**TOWN OF MOUNTAIN VILLAGE
REGULAR DESIGN REVIEW BOARD MEETING
THURSDAY NOVEMBER 2, 2017 10:00 AM
2nd FLOOR CONFERENCE ROOM, MOUNTAIN VILLAGE TOWN HALL
455 MOUNTAIN VILLAGE BLVD, MOUNTAIN VILLAGE, COLORADO
AGENDA**

TO: Design Review Board
FROM: Dave Bangert, Senior Planner
FOR: Meeting of November 2, 2017
DATE: October 25, 2017
RE: Initial Architecture and Site Review application for a new single-family dwelling on Lot 702

TO: Design Review Board
FROM: Sam Starr, Planner
FOR: Meeting of November 2, 2017
DATE: October 26, 2017
RE: Design Review application for a new single-family dwelling on Lot 628D

3 AREA PLAN - UPPER
1/16" = 1'-0"

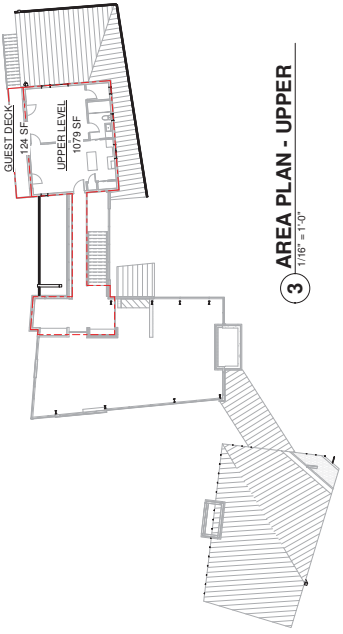
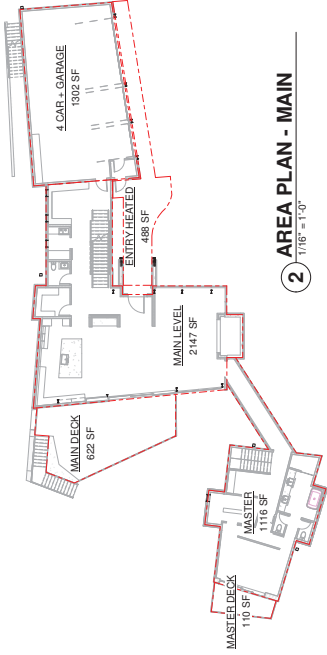
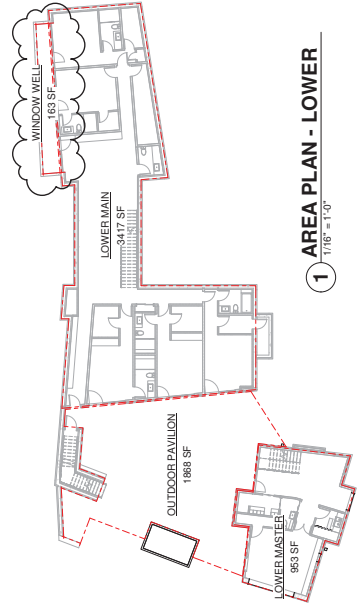
Please also be advised that new AREA calculations are on sheet A002. Total heated livable SF = 8,712. Garage is 1302 SF

Utility Plan

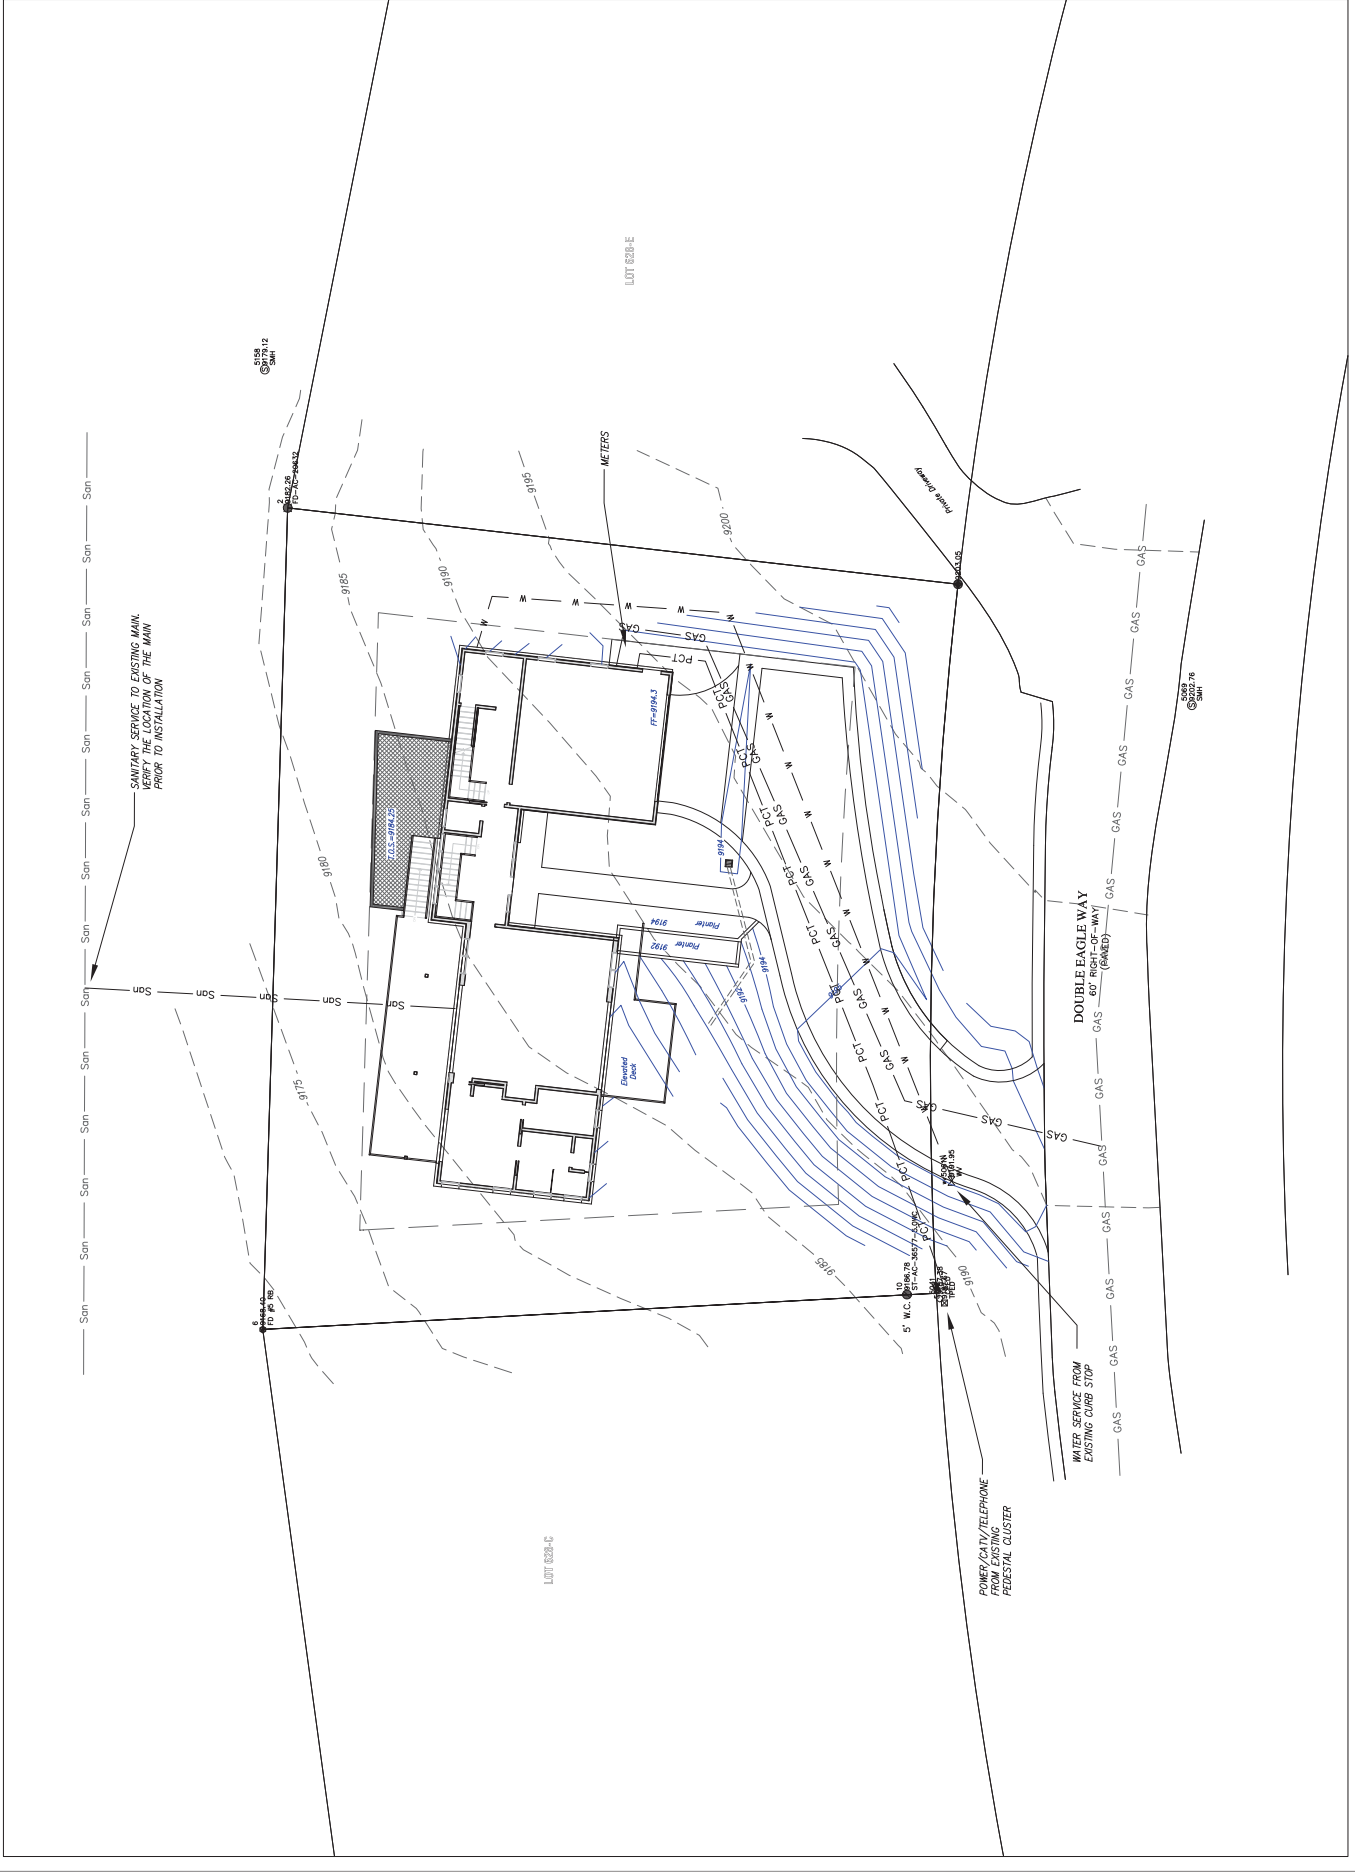
The proposed driveway has a maximum grade of 2.43%, and is 16' wide with 2' v-pan shoulders on each side. The applicant has revised his grading plan to demonstrate that parking in the auto-court is also outside of the General Easement.

NORTH ELEVATION
 1/4" = 1'-0"

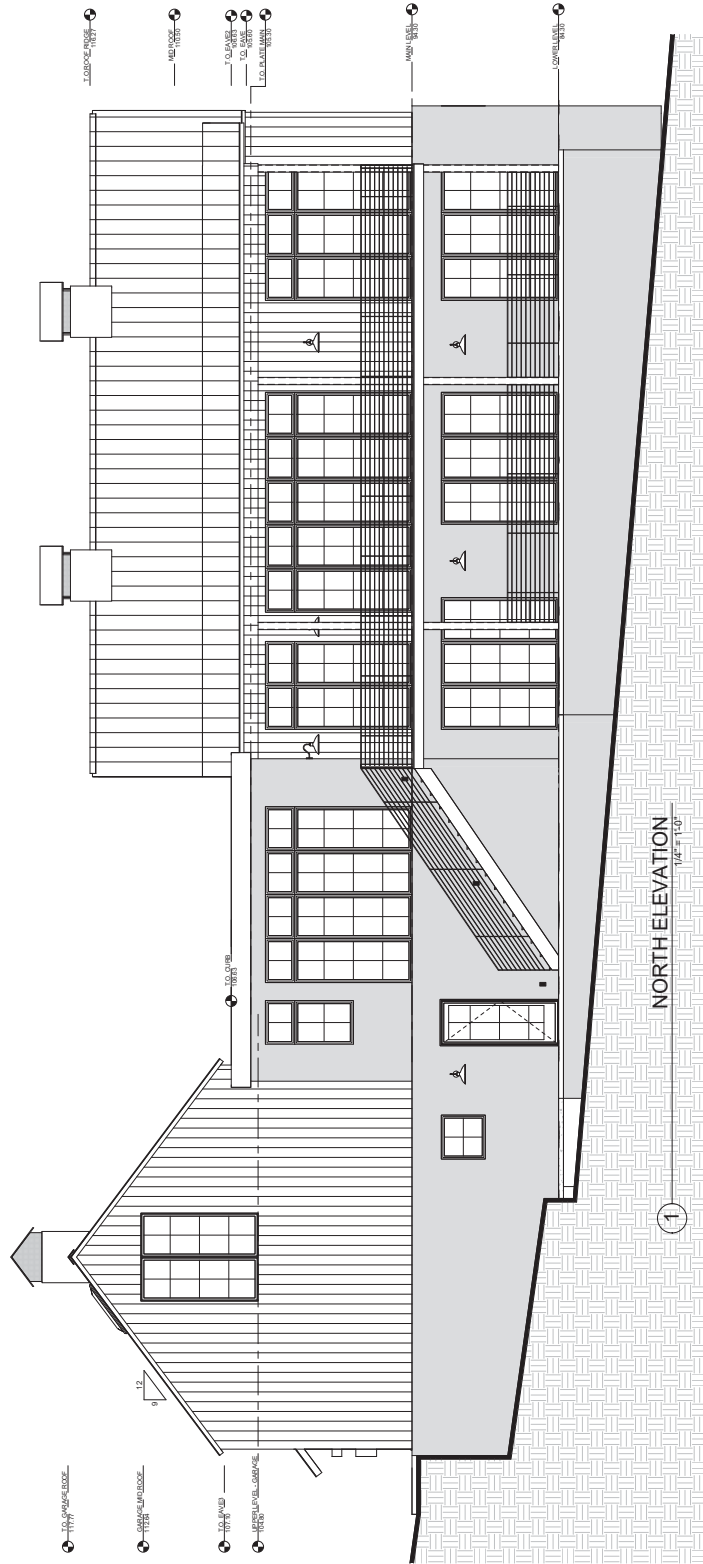
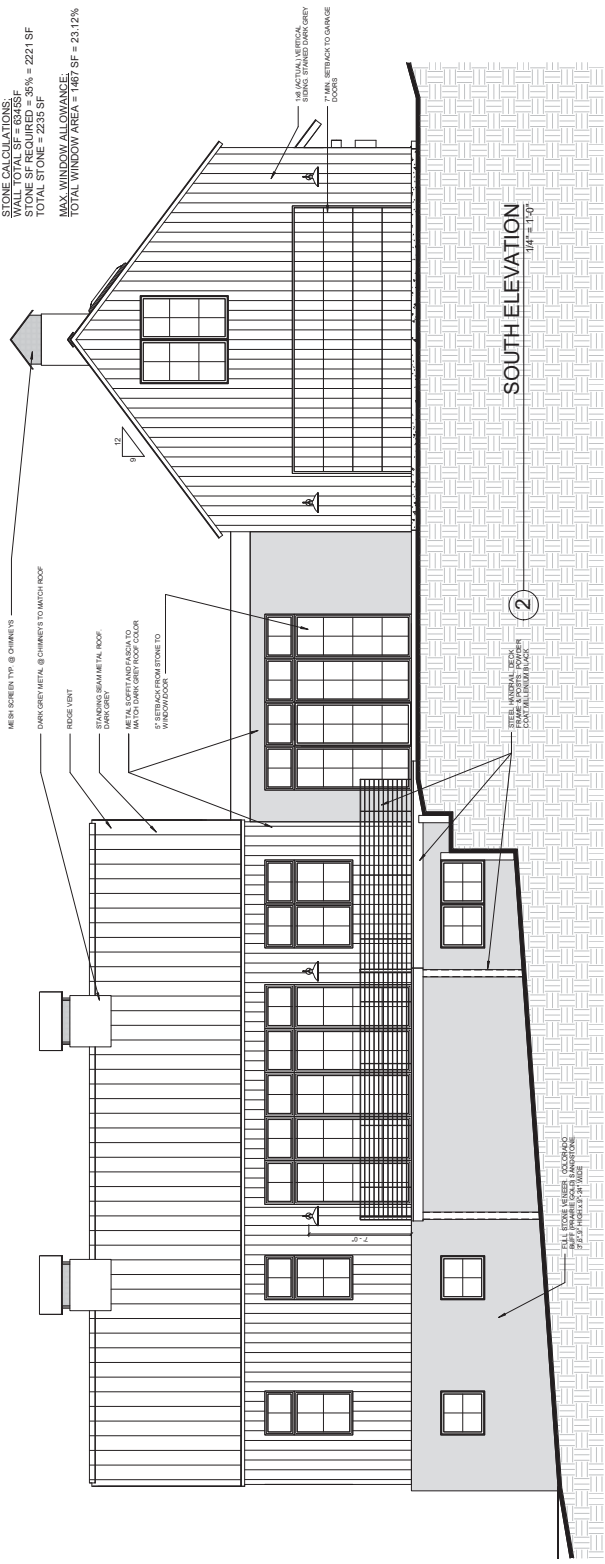
1. The chimney caps seem to be a little large for the size of the house and could possibly be revised to a smaller scale which would in my opinion create a more attractive elevation.
2. I am also opposed to any General Easement encroachment as I feel it sets a precedent for future developments and seems to be easily remedied by a slight redesign of the driveway.

In accordance with the DRB input and conditions of approval, the applicant has reduced height of the cupolas, submitted a lighting plan with reduced watt lightbulbs, and removed the portion of the southwest corner of the auto-court that encroached into the General Easement.
